CPED STAFF REPORT

Prepared for the Heritage Preservation Commission
HPC Agenda Item #2
February 16, 2016
BZH-28970

Property Location:	800 North 1st Street
Project Name:	Star Tribune sign replacement
Prepared By:	Mei-Ling Smith, City Planner, (612) 673-5342
Applicant:	Kevin Desmond, Star Tribune Media Co.
Project Contact:	Carol Lansing, Faegre Baker Daniels LLP
Ward:	3, adjacent to Ward 5
Neighborhood:	North Loop Neighborhood Association, adjacent to Northside Residents Redevelopment Council
Request:	To install an internally illuminated wall sign approximately 408 square feet in size in the St. Anthony Falls Historic District.

1 PC LETTERS ON PAN

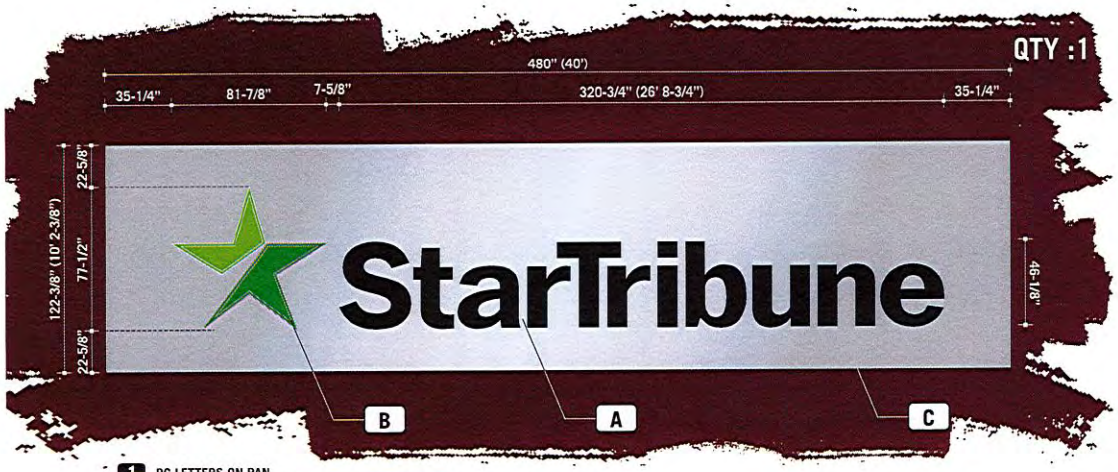
Size: The proposed sign is 408 square feet in area and 10.2 feet in height, which exceeds the 32 square foot area maximum and two foot height maximum in the guidelines. In addition, the wall sign would extend nine inches from the building, which exceeds the guidelines' eight-inch maximum. The request to exceed the area, height, and projection is reasonable given that the northwest elevation is over 670 feet long and there are no other signs on this side of the building.

Staff finds that the size, projection, and color of the proposed sign design warrants flexibility from the design guidelines, and is recommending conditions of approval related to the color and height of the backer pan.

Recommended motion: **Approve** the certificate of appropriateness to allow a 408 square-foot internally illuminated wall sign, subject to the following conditions:

1. The backer pan shall be painted metallic gray or anodized aluminum.
2. The height of the backer pan shall not exceed 10 feet, 3 inches.
3. By ordinance, approvals are valid for a period of two years from the date of the decision unless required permits are obtained and the action approved is substantially begun and proceeds in a continuous basis toward completion. Upon written request and for good cause, the planning director may grant up to a one year extension if the request is made in writing no later than February 16, 2018.
4. By ordinance, all approvals granted in this certificate of appropriateness shall remain in effect as long as all of the conditions and guarantees of such approvals are observed. Failure to comply with such conditions and guarantees shall constitute a violation of this Certificate of Appropriateness and may result in termination of the approval.
